# Access Compliance Report

## Public Rights-of-Way (Curb Ramps)

Intersection ID: 10033082	Main Street: NORTH_REA_PARK_LN	Cross Street: N/A	Location: S
ADA ID: 0604428A44F4	Ramp Type: Perp	Initial Pass/Fail: Fail	Overall Compliance: No
Severity Score: 12.5			
Codes/Mitigation Info/Possible Solution		Field Measurements/Component Compliance

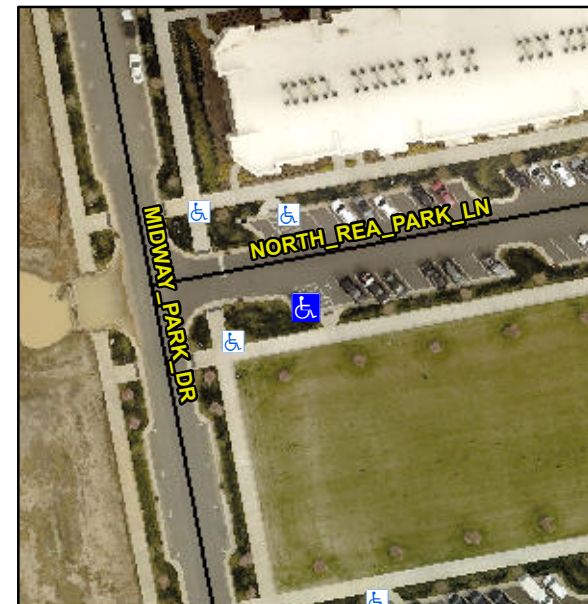
**Not Found, R304.2.2**

Compliance	Description	Data	Compliance	Description	Data
N/A	Ramp Length (in)	95.0	No	Ramp Slope (%)	8.7
Yes	Ramp Width (in)	59.5	Yes	Ramp XSlope (%)	0.2
N/A	Flare Type LT	N/A	N/A	Flare Type RT	N/A
N/A	Flare Slope LT (%)	N/A	N/A	Flare Slope RT (%)	N/A
N/A	Flare Traversable LT?	N/A	N/A	Flare Traversable RT?	N/A
N/A	Landing Length (in)	N/A	N/A	DWS Provided?	N/A
N/A	Landing Width (in)	N/A	N/A	DWS Contrast?	N/A
N/A	Landing Slope (%)	N/A	N/A	DWS Length (in)	N/A
N/A	Landing X Slope (%)	N/A	N/A	DWS Full Width?	N/A
N/A	Landing Curb? (Y/N)	N/A	N/A	DWS Offset (in)	N/A
N/A	Shared Landing?	N/A			
N/A	Gutter Ponding?	N/A	N/A	Gutter Slope (%)	N/A
N/A	Gutter Lip Ht (in)	N/A	N/A	Gutter X Slope (%)	N/A
N/A	Painted X Walk1?	No	N/A	Painted X Walk2?	N/A
	X Walk 1 Direction	To N		X Walk 2 Direction	N/A
N/A	X Walk 1 Width (in)	N/A	N/A	X Walk 2 Width (in)	N/A
	X Walk 1 Slope (%)	3.6		X Walk 2 Slope (%)	N/A
	X Walk 1 X Slope (%)	1.7		X Walk 2 X Slope (%)	N/A

**Remove & Replace Entire Ramp.**
